Ongoing log of questions and clarifications during WFD reporting

Jon Maidens, Mette Wolstrup, WFD Helpdesk log, version 11-04-2012

The following is a list of open issues that have arisen in the WFD River Basin Management Plan reporting period starting October 22 2009. This list covers comments/issues identified with the schemas and the database and the appropriate action/response.

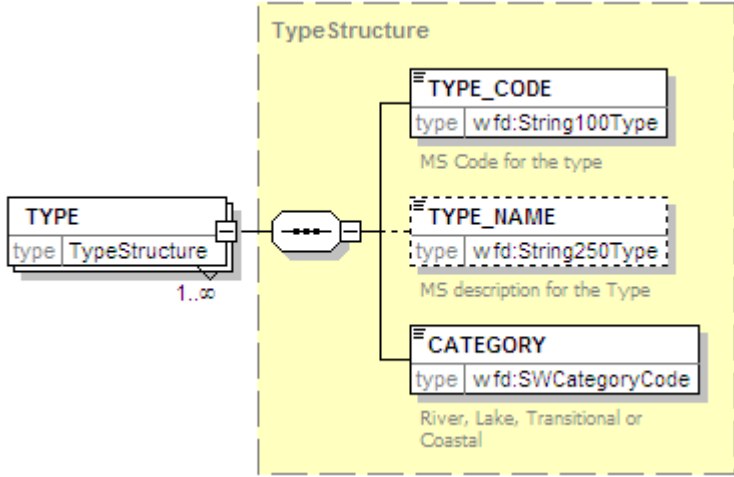
12.	FR	SWB	Different districts face the same problem with the protected Areas in SWB schema (for SWB_protectedAreaStatus table) : it is not permitted by xsd to have « UWWT » protected area type, though this type exists in PA schema. It seems to us relevant to report UWWT areas regarding to SWB. In order to validate the schema, we change the area type to "European Other" in SWB schema. Would it be possible to allow the UWWT protected	The UWWD choice is not given in the field SurfaceWaterBodies/SurfaceWaterBody/StatusProtectedAreas/SWProtectedAreaDetails/TypeOfProtectedArea because there is no definition of "status" in the UWWTD. The identification of sensitive areas defines the level of treatment needed for the waste water treatment plants. The eutrophication and other aspects of status of the water body is captured in the assessment of WFD status. What is confusing in the schema is that the field SurfaceWaterBodies/SurfaceWaterBody/StatusProtectedAreas/PROT_AREA_ASSOC asks whether there is a protected area associated. If you have a

| No.	Reporter	Area	Issue	Response
			area type in the SWB schema ?	sensitive area associated it seems that you should mark "Yes", but then you have to fill in the SWProtectedAreaDetails that do not give the possibility to select UWWTD. It is important, however, to make the link between protected areas and water bodies, and this is done in this part of the schema only. Therefore, in case a sensitive area associated with a water body, it is recommended to report as follows: SurfaceWaterBodies/SurfaceWaterBody/StatusProtectedAreas/PROT_ARE A_ASSOC = "Yes" SurfaceWaterBodies/SurfaceWaterBody/StatusProtectedAreas/SWProtect edAreaDetails/TypeOfProtectedArea = "EuropeanOther" SurfaceWaterBodies/SurfaceWaterBody/StatusProtectedAreas/SWProtect edAreaDetails/ProtectedAreaCode = [the codes used in the ProtArea schema; with this link it will be possible to identify that the type of protected area is UWWTD sensitive area] SurfaceWaterBodies/SurfaceWaterBody/StatusProtectedAreas/SWProtect edAreaDetails/TypeOfAssociation =[as appropriate] and the rest of the fields: SurfaceWaterBodies/SurfaceWaterBody/StatusProtectedAreas/SWProtect edAreaDetails/ValueStatusProtectedArea SurfaceWaterBodies/SurfaceWaterBody/StatusProtectedAreas/SWProtect edAreaDetails/CommentValueStatusProtArea

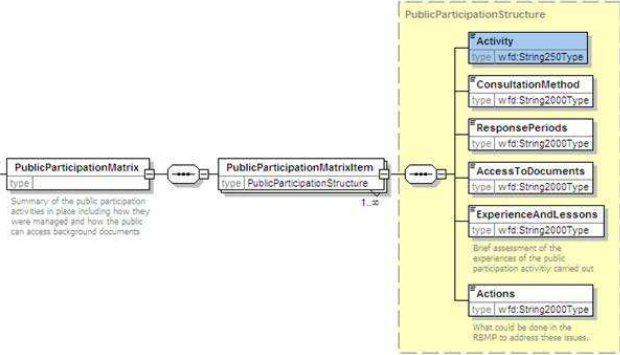
6.	SK	GWMethods	Regarding GWMET schema I would like to ask, can we ignore validation error for GWFurtherCharacterisationRef'? (See Access database, GWMET schema and validation message in in attachment)? Do I understand it correctly, the error for '"GWFurtherCharacterisationRef'" is linking to the Access table „GWMET_ReferenceLINKS"? But this table is not mandatory, is it? We validated XML GWMET when the table „GWMET_ReferenceLINKS" was empty and also when the table „GWMET_ReferenceLINKS" was filled in test version. But the validation errors were the same for both of XMLs.	The schema design implies that the GWFurtherCharacterisationRef should be provided as also the annotation text does: "Hyperlinks to more detailed supporting documents (e.g. methodology documents) should be provided." The GWFurtherCharacterisationRef is therefore defined as mandatory information and can't be left out. It is correct that GWFurtherCharacterisationRef is linked to the table GWMET_ReferenceLINKS. In this table it is possible to choose the table link "GWMET_FurtherCharacterisation" - please see attached screen dump.

No.	Reporter	Area	Issue	Response
			Could you please helps us what is wrong with table „GWMET_ReferenceLINKS". Or can we ignore this validation error and let this table empty? Because no one table form enumeration list for "Table_Link" have additional documentation available. Documentation will be available in Background documents

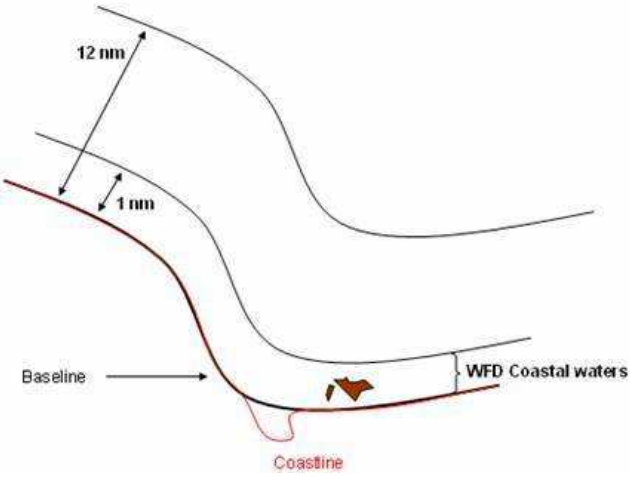
| 3. | FR | Document/ Shapefile templates | Shapefile template is missing for River Basin Districts/Sub-Units | The shape file should only have two attributes – EU_CD_RB (equivalent to EURBDCode - mandatory), EU_CD_SU (equivalent to EUSubUnitCode - mandatory). All other properties are the same as other templates.

No.	Reporter	Area	Issue	Response
				At least one Sub-unit must be declared for each RBD. If there is only one Sub-unit then enter the RBD code (EU_CD_RB) into the EU_CD_SU.

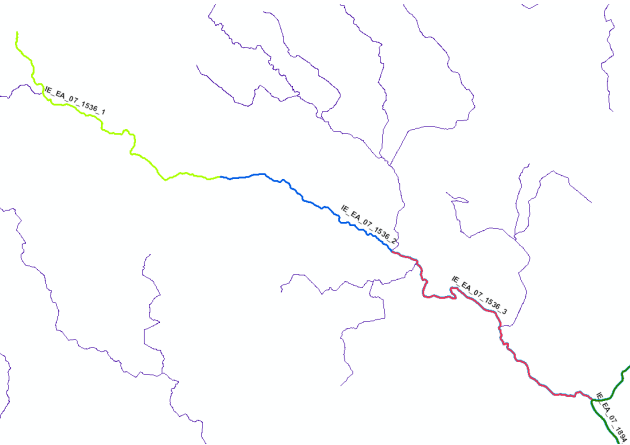
15.	BG		Why we need the attribute "MAIN" in the River water bodies shape file , if In the table "Spatial dataset identification" in art.8.1 (page 39) the requirement for the River spatial dataset is "River water bodies have a catchment area > 10 sq km, BUT	This is because the model for reporting spatial information assumes that the water bodies are elementary segments, in line with the WFD definition of water body (a river or part of a river). However, grouped water bodies can be reported as single elements and this optional attribute MAIN is meant to flag those segments which are part of the WISE 'main' river, to

| No.	Reporter	Area	Issue	Response
			only those with catchment area > 500 sq km are included. The remainder are delivered as centroids only "	differentiate them from the branches.

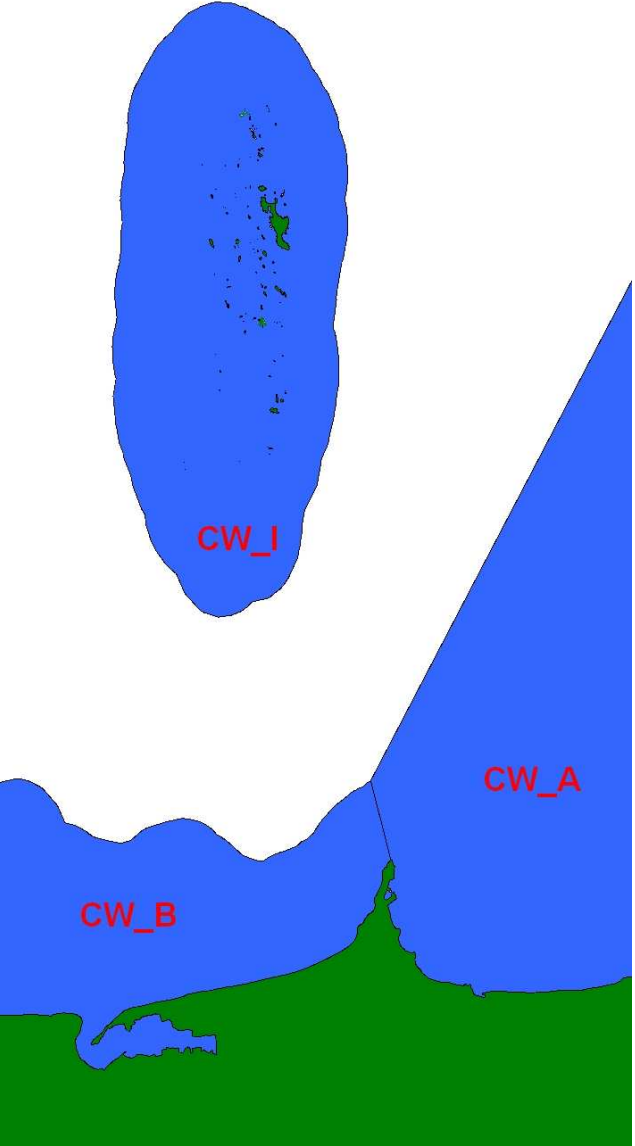
Is it possible to change the attribute to a string of length = 3 (e.g. 2-4 would mean position ranging between 2 and 4), or do you propose another solution ?

| No.	Reporter	Area	Issue	Response			
			we want clearly non-overlapping GWB's within one shape file and Horizon Type, this would lead to a multiplication of Horizon Types. Did we understand this correctly and should we proceed in that direction ? c) We have some GWB's smaller than 100 km² : -can we deliver these shape files with all attributes or -can we only deliver the centroids and are we not allowed to deliver the shape files ? Thank you in advance for your help,				to hold a second horizon to provide a range. See section 7.2.6.3 for code list and description.
